**Modification/Change Order No.1**  
 PO #: 215963  
 Fort Bend County Drainage District  
 Flat Bank/ Steep Bank Channel Bank Stabilization.  
 Fort Bend County, Texas  
 October 27, 2022

| <b>CHANGE ORDER/MODIFICATION NO. 1</b>  |  | Effective Date:   | Page 1 of 2 |
| Contract: PO 215963   | Dated: 9/19/2022   | Project: EWP – Flat Bank/ Steep Bank Channel Bank Stabilization |             |

**FB Flat Steep Bank Site 20 and Existing Rock Slough at Site 19 - Proposed Change Order/Modification**

DETAIL "A"  
 N.T.S.

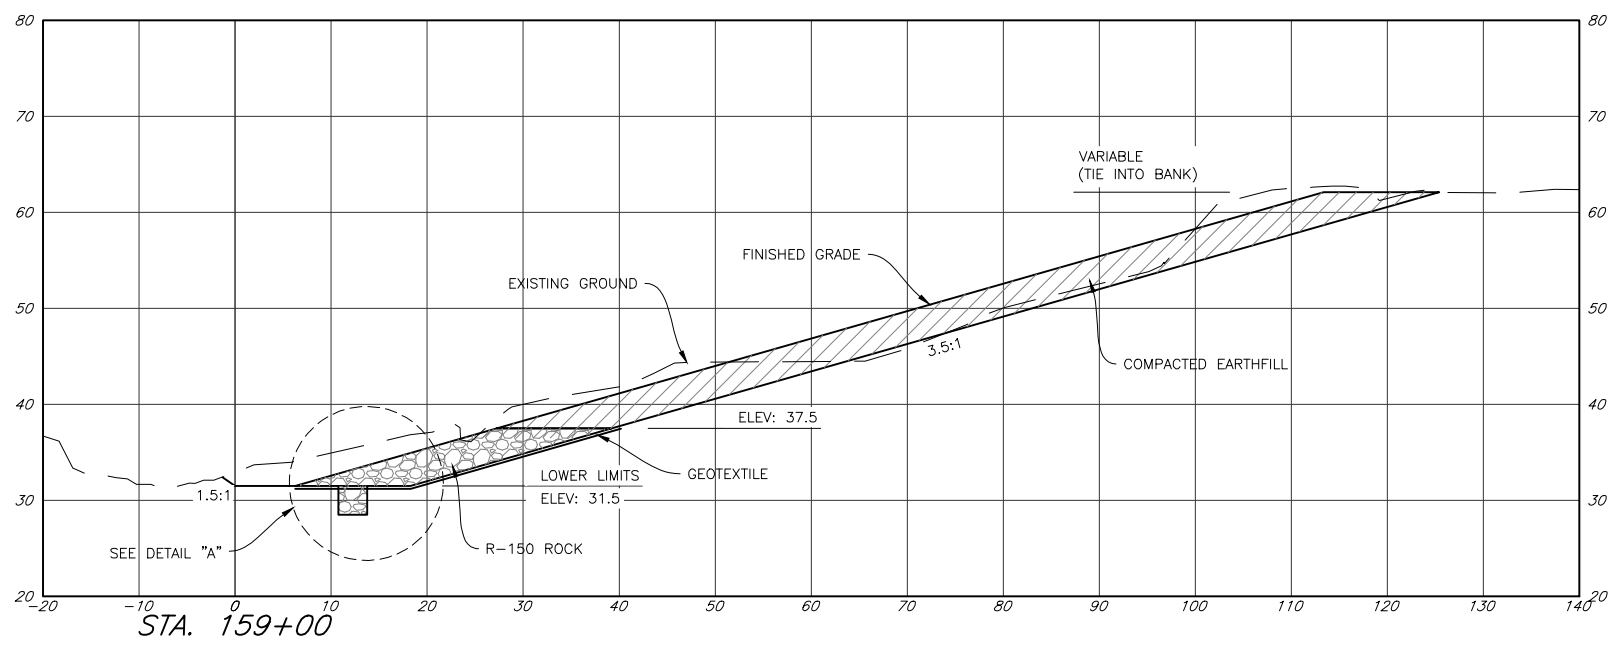
A 25 FEET TRANSITION AREA FOR THE EXCAVATION AND FINISHED GRADE SHALL BE ADDED AT EACH END OF THE REPAIR AREA SHOWN TO TRANSITION TO THE EXISTING CHANNEL CONFIGURATION.

SECTION VIEW

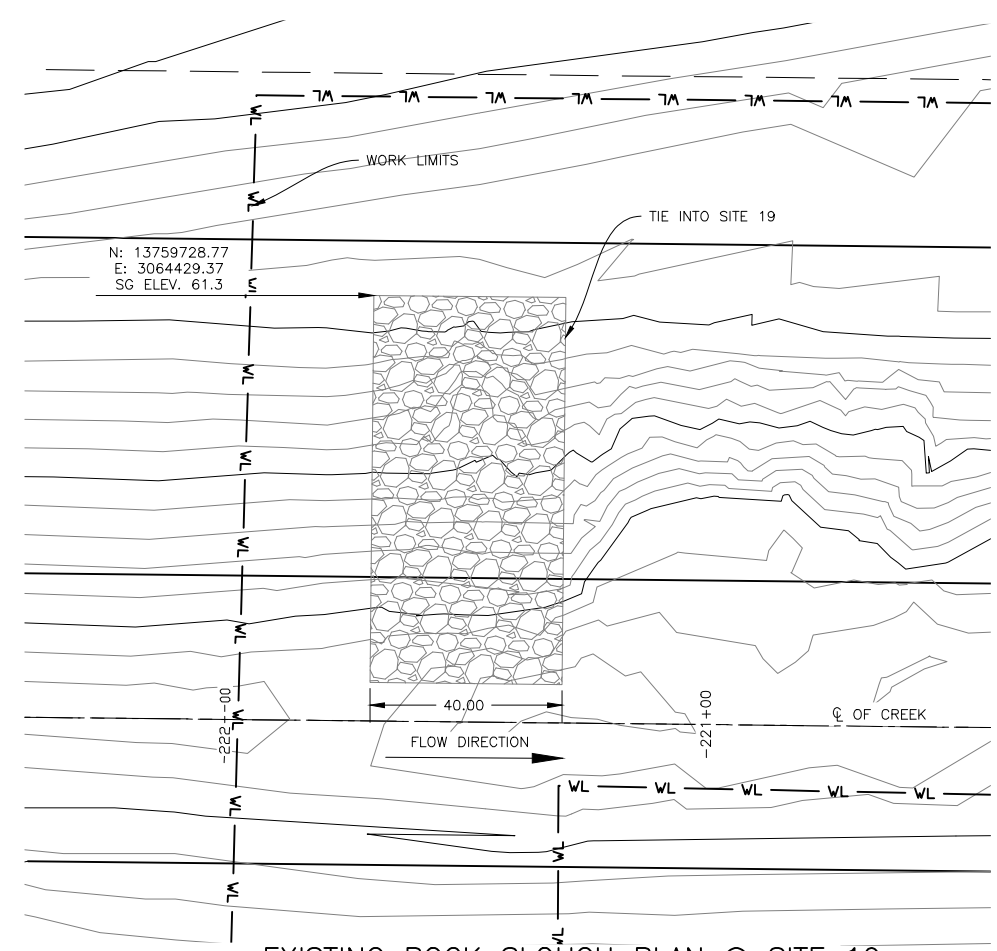
Site 20 shall be added as shown on the attached drawing, Site 19 shall be extended to include the work shown on the attached drawing. All added work shall be accomplished as specified in the contract’s applicable construction and material specification.

EXISTING ROCK SLOUGH PLAN @ SITE 19

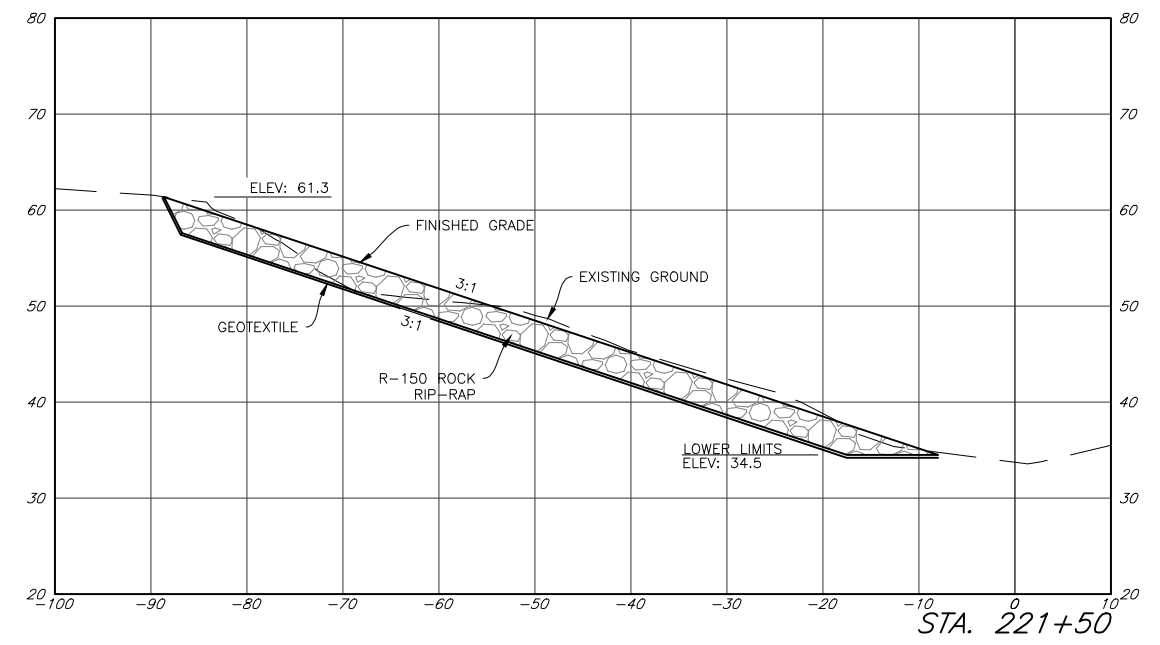
| 3) Rock repair upstream site 19. Remove existing riprap, salvage and replace.  |

NOTE:  
 THE WORK INCLUDES REMOVING AND SALVAGING THE EXISTING ROCK, PREPARING THE SUBGRADE AND PLACING THE SALVAGED ROCK ON THE PREPARED SUBGRADE. THE SUBGRADE SHALL BE PREPARED BY REMOVING LOW DENSITY MATERIAL AND REPLACING WITH COMPACTED EARTHFILL TO A 3:1 SLOPE. THE SUBGRADE SHALL BE APPROVED BY THE ENGINEER BEFORE PLACEMENT OF THE ROCK.
